RHODES BUSINESS PARK

TECHNICAL NOTE

Flood Zone Analysis Modelling Results

Document No: 40055-BGL-XX-XX-TN-C-00006

Figure 3-2: Baseline 100-year flood extent with climate change

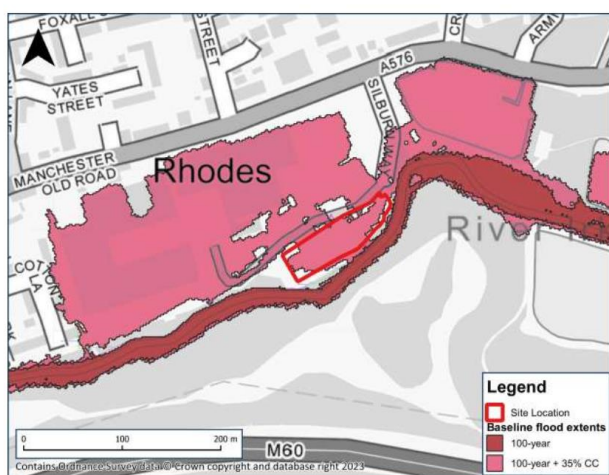
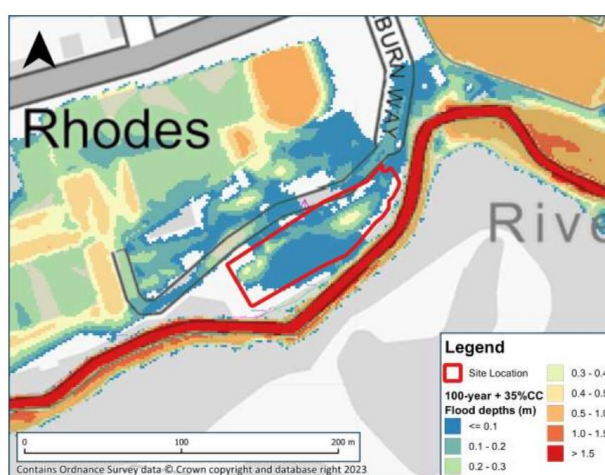
EA Comment: 23 May 2024

Flood Mitigation and Storm Events

The site is not prone to flooding for the 100 year storm event.

The site is at risk of flooding for the 100 year +35% climate change storm event. The predicted flood depths are generally less than 100mm across the site.

Figures 3-2 and 3-3 from the JBA report are reproduced below for reference showing the predicted flood extents and levels for the base line scenario (pre-development):

From Figure 3-2, above, and satellite image, below, the flood area extent reaches the existing industrial site and the park pond/basin to the northeast measuring ~42,500m² in plan area. The industrial estate is part of the development site which is owned by the applicant

As can be seen in the JBS report figure 3-2, the primary overland flood routing is along Silburn Way through the industrial estate and rejoins the River Irk to the west of the property. The levels on Silburn Way drop from north to south into the industrial estate and then level out with the lowest levels in the estate at the western boundary along the river where the flow path rejoins the river.

There is a small breach along the River Irk along the southern boundary of the proposed development which floods the area - JBA Figure 3-4. The proposed levels for this development will reinstate the flood defence levels and prevent water entering the industrial estate thus reducing flood inflows to the industrial estate.

The introduction of the proposed development does not impede this overland flood flow path.

Figure 5-2: Post development flood depths

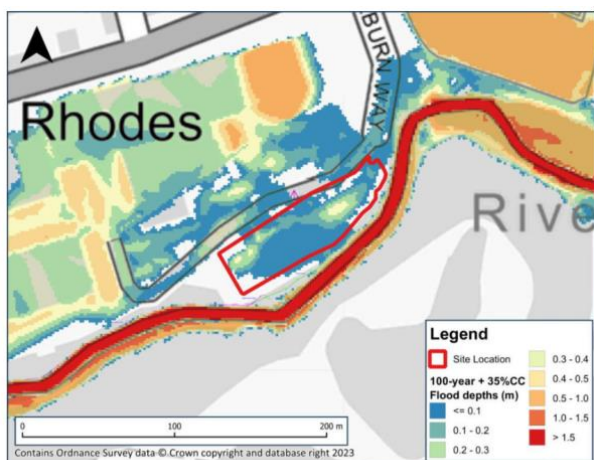
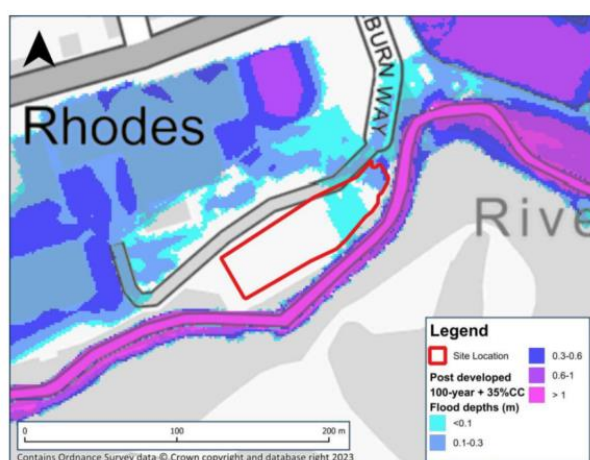
EA Comment: 15 August 2024

Flood Compensation:

Further to the recent correspondence with the Environment Agency raising concern with the volume of flooding that was predicted with the predevelopment analysis scenario.

JBA were commissioned to undertake a post development flood analysis to append onto their original report. This study was undertaken to better understand the levels and extents of the flooding during the 100yr+35CC storm event. The final JBA Report is included in the Appendix.

The figures below are taken from the Final JBA report and show the pre and post development flood depth for the 100yr+35%CC event.

The findings of the post development flood analysis are as follows:

- There is shallow flooding across the site in the 100-year plus climate change (35%) event but this is limited to 5cm in depth.
- The impact map shows some increases in maximum flood depth to the immediate north along Silburn Way, although there is also a betterment within the industrial area to the north and north-west.
- The study shows that there are reductions in flood depths post development
